IOWA DOT	REVISION	
	4	10-15-24
STANDARD ROAD PLAN		BR-203
REVISIONS: Added Longitudinal Grooving in Concrete to possible contract item. Added 'BE' joint detail.		SHEET 1 of 3
 APPROVED BY DESIGN METHODS ENGINEER		
DOUBLE REINFORCED 12" APPROACH

IOWA DOT STANDARD ROAD PLAN	REVISION	
	4	10-15-24
		BR-203
		SHEET 2 of 3

'BE' JOINT DETAIL

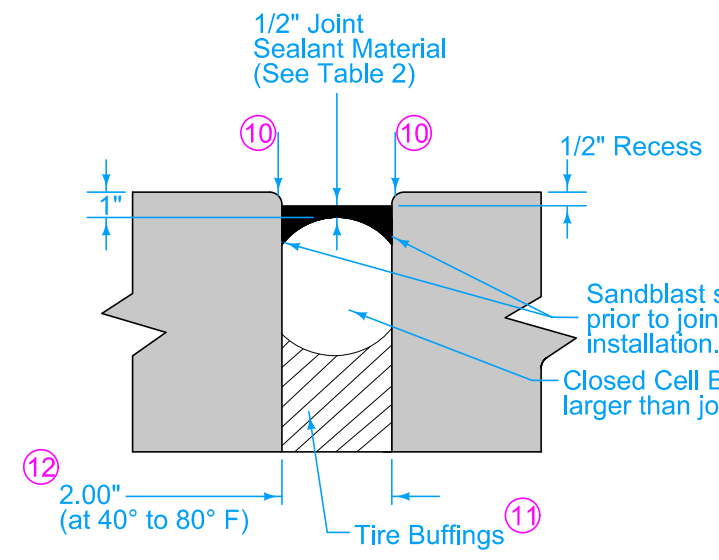
STANDARD ROAD PLAN	REVISION	
	4	10-15-24
	BR-203	
SHEET 3 of 3		
REVISIONS: Added Longitudinal Grooving in Concrete to possible contract item. Added 'BE' joint detail.		
 APPROVED BY DESIGN METHODS ENGINEER		
DOUBLE REINFORCED 12" APPROACH

- ⑫ Setting Width Notes:
 - Width is perpendicular to abutment.
 - Temperature of concrete deck on the underside or shaded portion of the deck shall be between 40 to 80 degrees Fahrenheit when placing approach slab concrete.

- This 'BE' joint and the setting temperatures may be used for all concrete beam or slab bridges up to 575' in length and for all steel girder bridges up to 400' in length.
